STATE OF HAWAII DEPARTMENT OF TRANSPORTATION HIGHWAYS DIVISION MECHANICALLY STABILIZED EARTH RETAINING WALL (MSERW) TYPICAL SECTION AND DETAILS KAHKILI HIGHWAY WIDENING Likelike Hwy. to Vicinity of Haiku Road F.A. PROJECT NO. NH-083-1(26) SCALE: AS NOTED DATE: APRIL 1994 SHEET No. W1 OF W21 SHEETS	
--	--

AS-BUILT ADD. 114

KAHEKILI HIGHWAY WIDENING
Likelike Hwy. to Vicinity of Haiku Road
F.A. PROJECT NO. NH-083-1(26)

STATE OF HAWAII DEPARTMENT OF TRANSPORTATION HIGHWAYS DIVISION	
PLAN AND PROFILE R.C. WALL NO. 19	
KAHEKILI HIGHWAY WIDENING Likelike Hwy. to Vicinity of Haiku Road F.A. PROJECT NO. NH-083-1(26)	
SCALE: AS NOTED	DATE: APRIL 1994
SHEET No. W20A OF W21 SHEETS

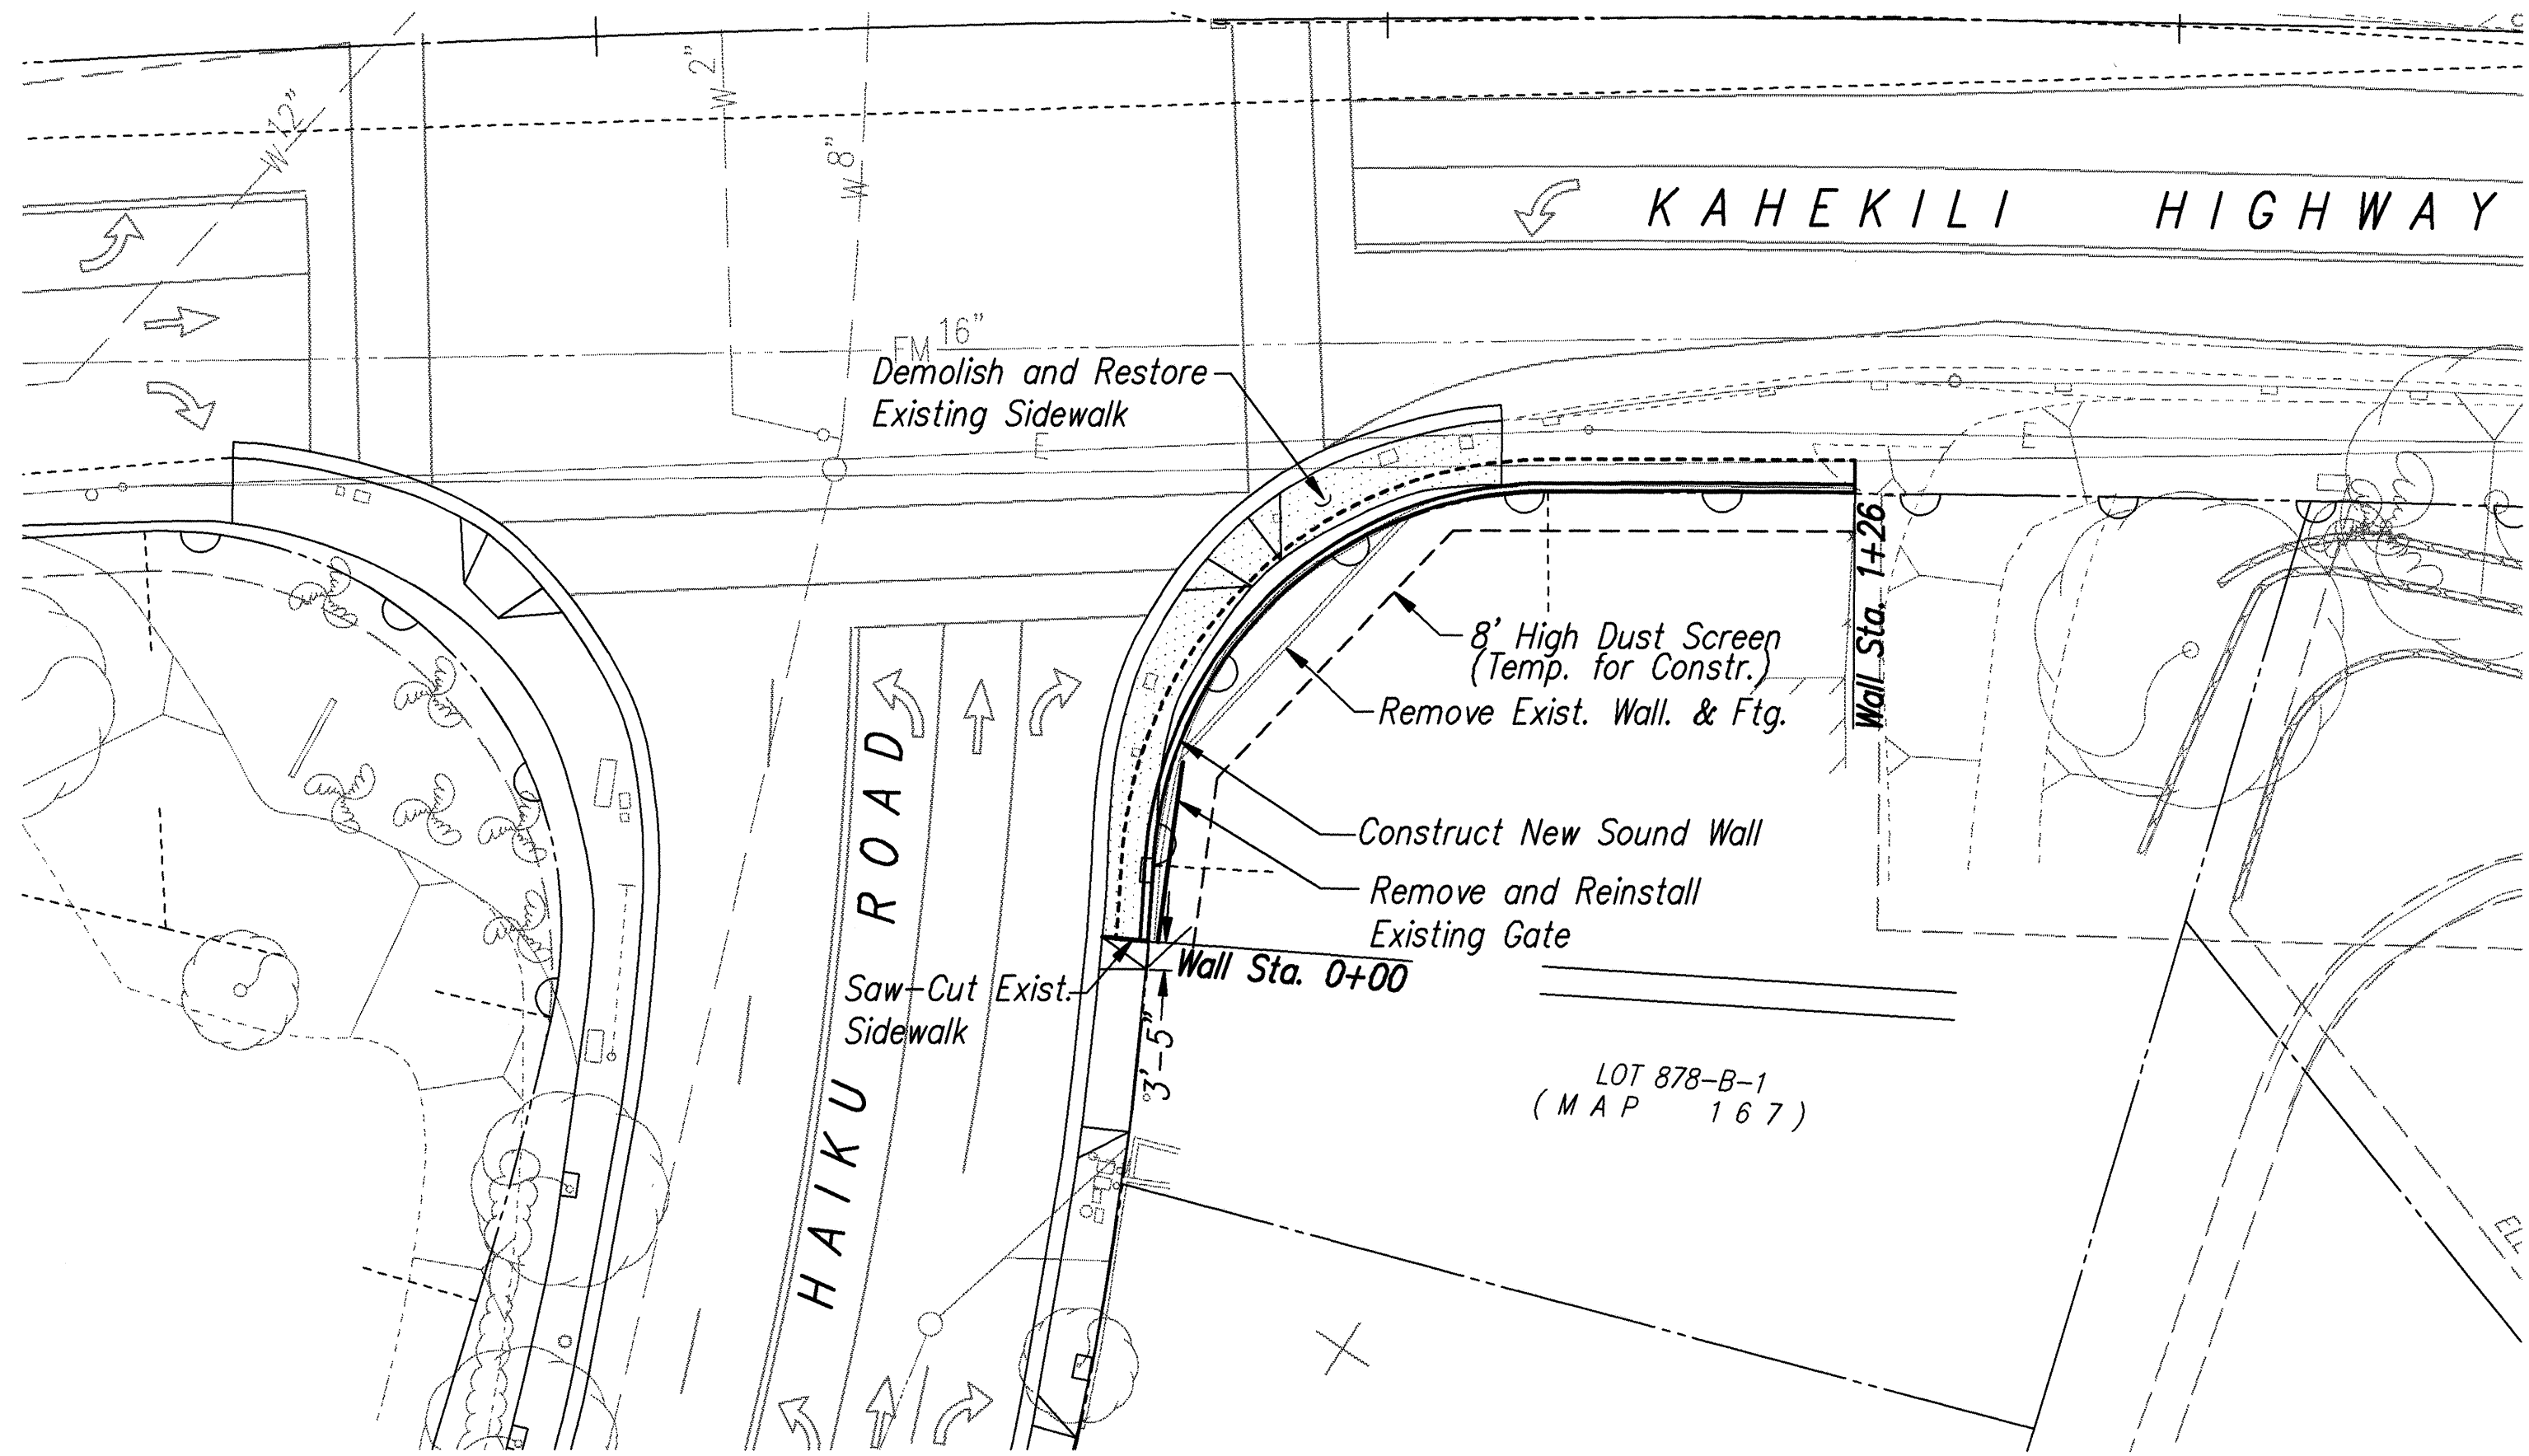
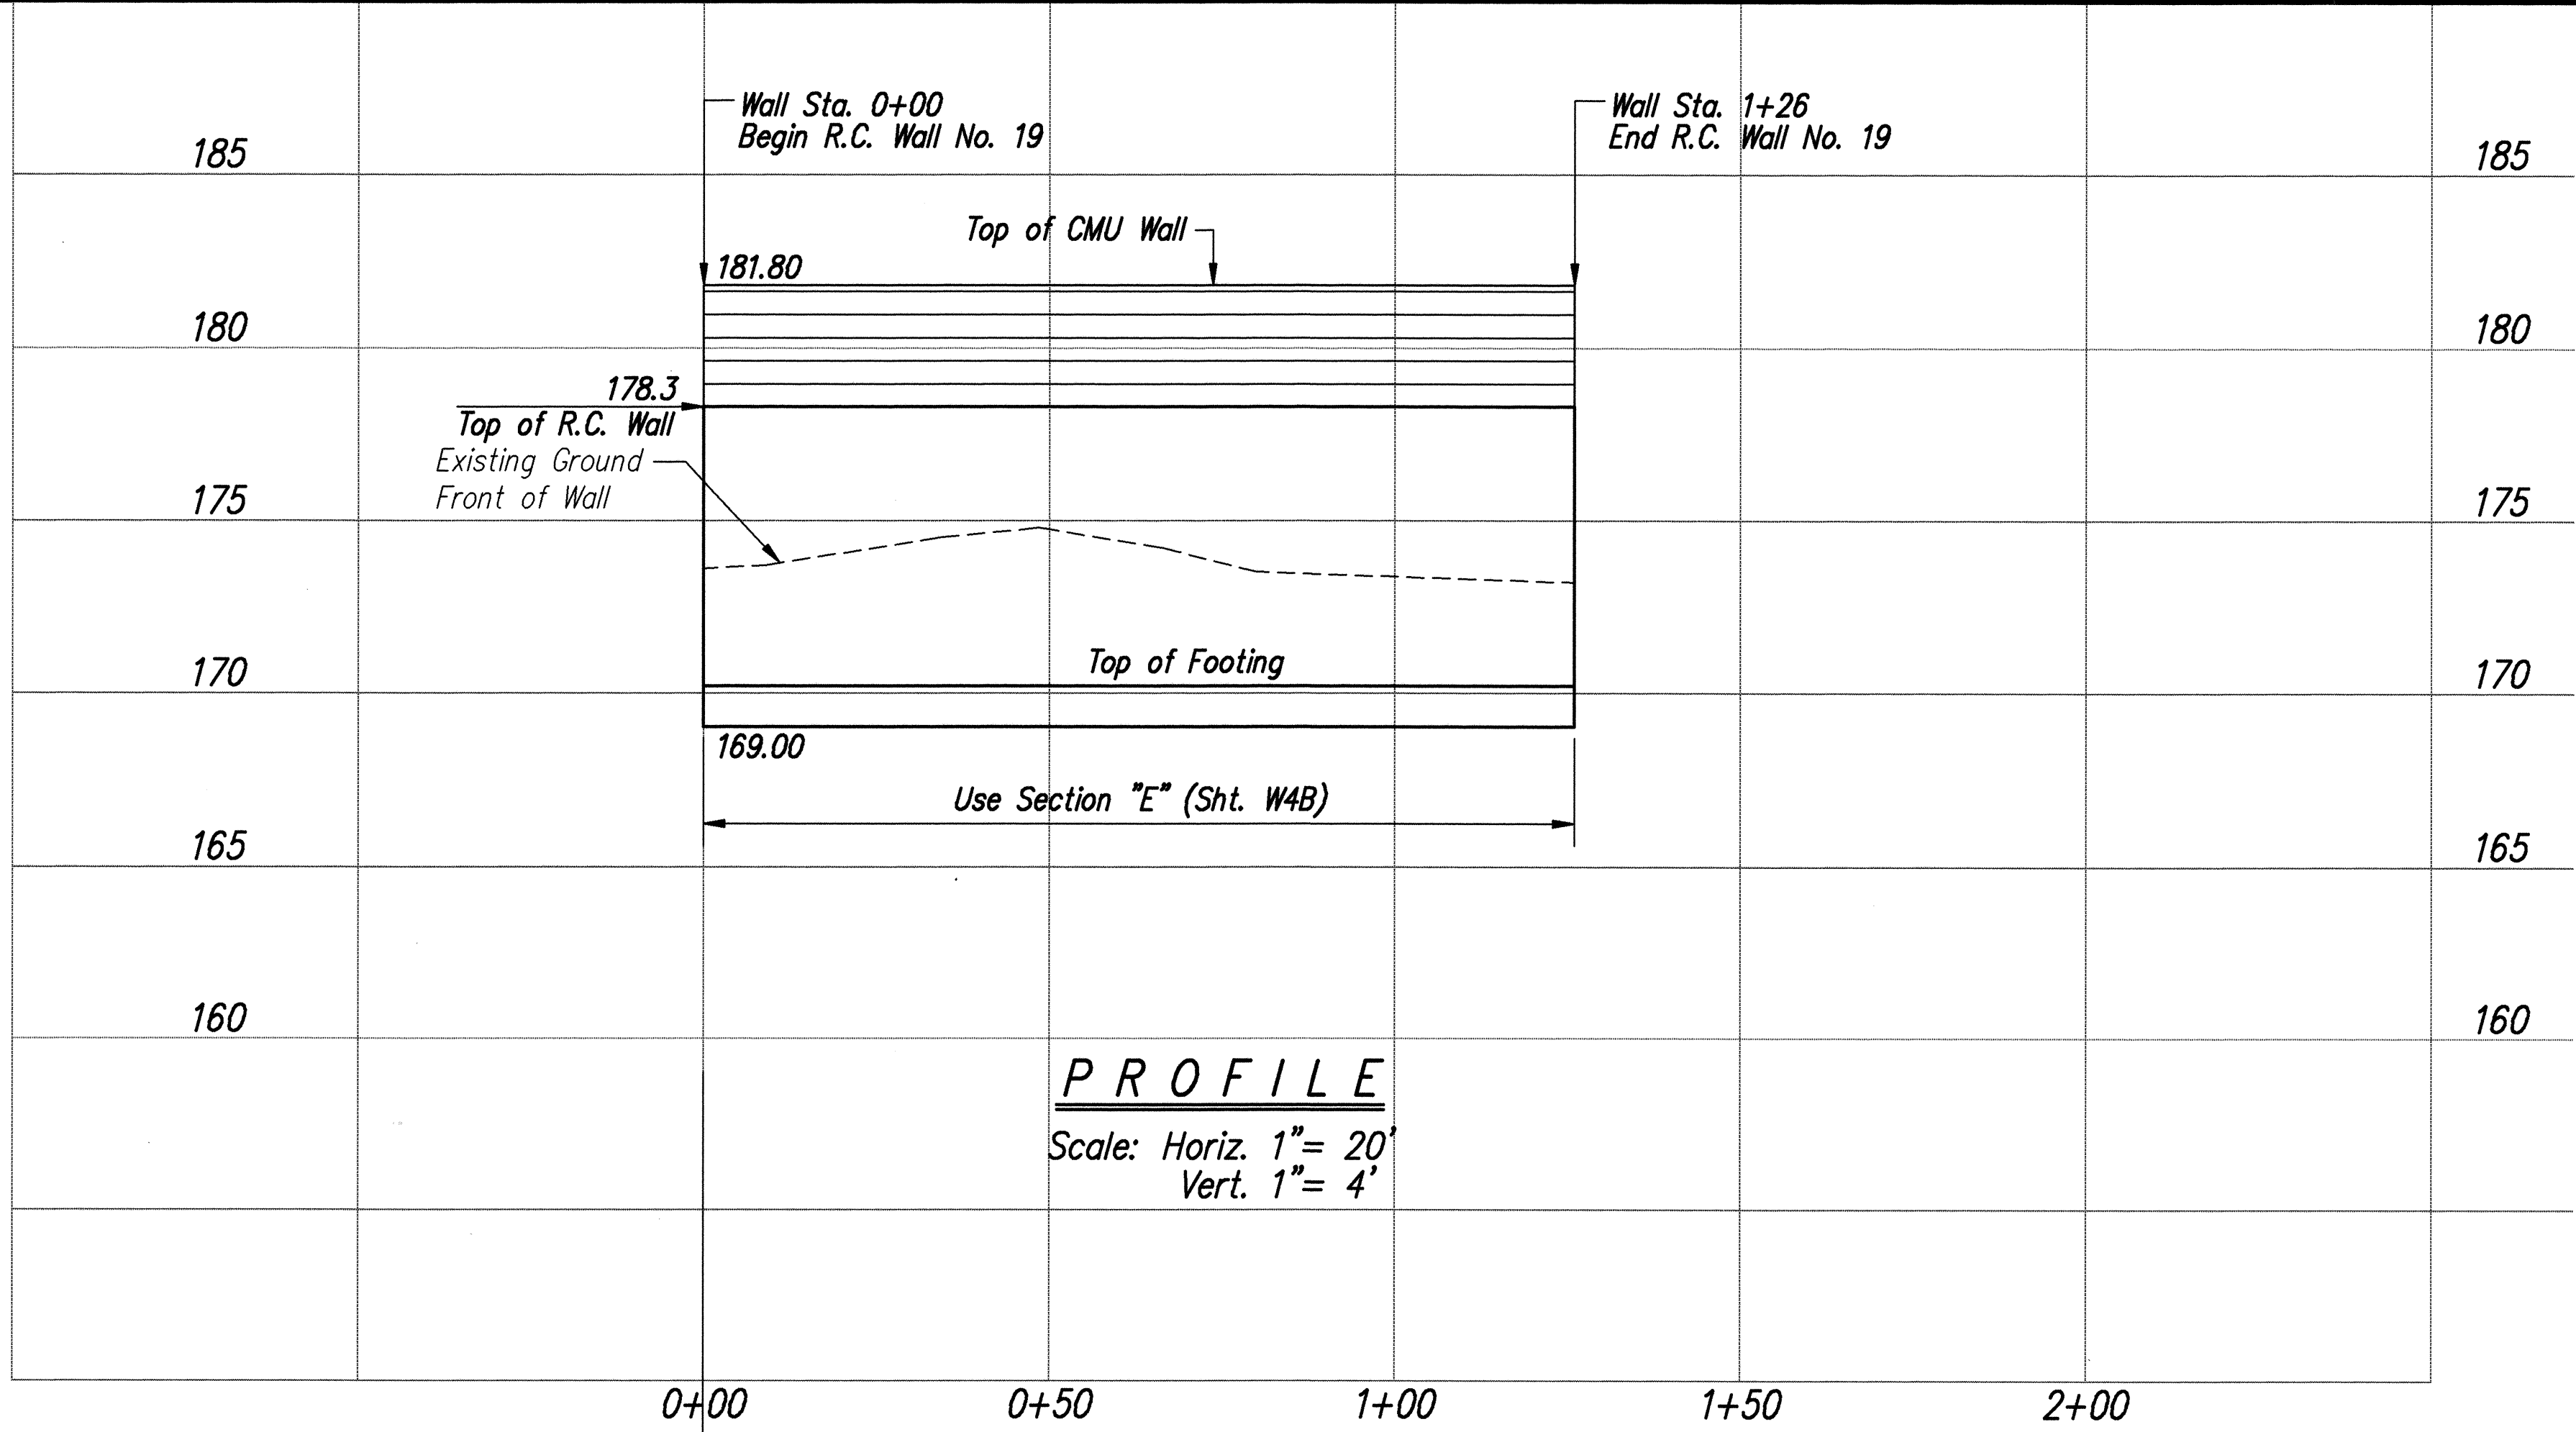
4/29/97	ADDED R.C. WALL NO. 19.
DATE	REVISION
